**CITY OF ROCKVILLE PLANNING DIVISION
STAFF REPORT**

April 16, 2001

Detailed Application CPD2000-0004K for
Comprehensive Planned Development
CPD1999-0004, Fallsgrove

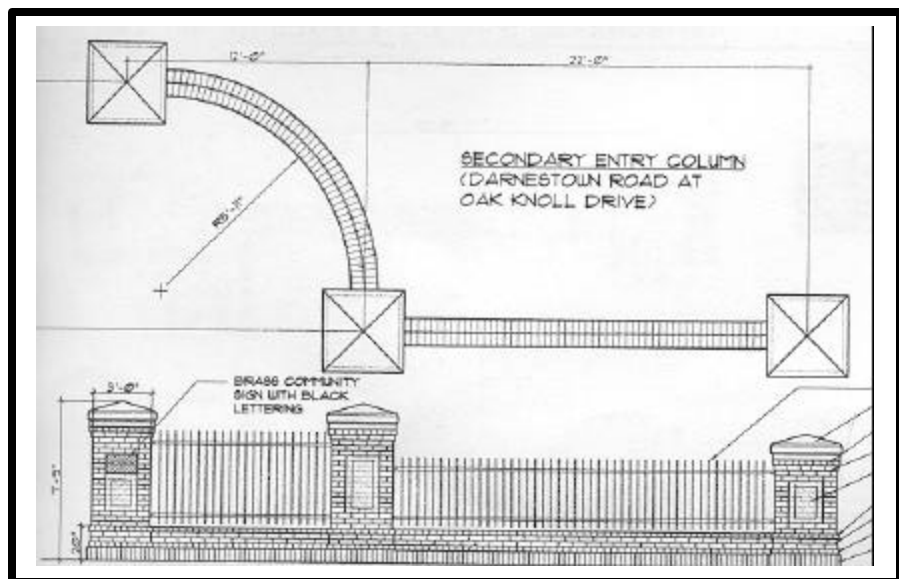
The plans that accompany this application show the landscaping and bike path starting at the intersection of West Montgomery Avenue and Darnestown Road, adjacent to an approved stormwater pond. This report's discussion will start here and travel clockwise around the site. In the landscaping area adjacent to this pond, there will be a decorative guardrail and low plantings that are consistent

with stormwater pond plantings. There will be no street trees planted in this area given the location of an existing storm drain lines (see attached sheet L-2).

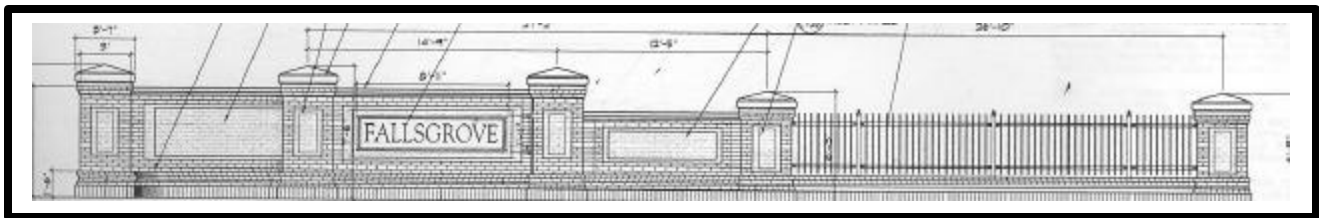
The theme of the plan across the JPI and Village Center frontage remains consistent, with a combination of landscape elements and perimeter wall features. There are also monumental entry features at the intersection of Falls Grove Boulevard and Shady Grove Road as outlined on sheet L-11 and L-12. The specifics of this monumentation

include a brick and pre-cast concrete design combined with architectural fencing. At an overall height of seven feet, six inches, this corner is treated as a formal entry to the most urban part of Falls Grove.
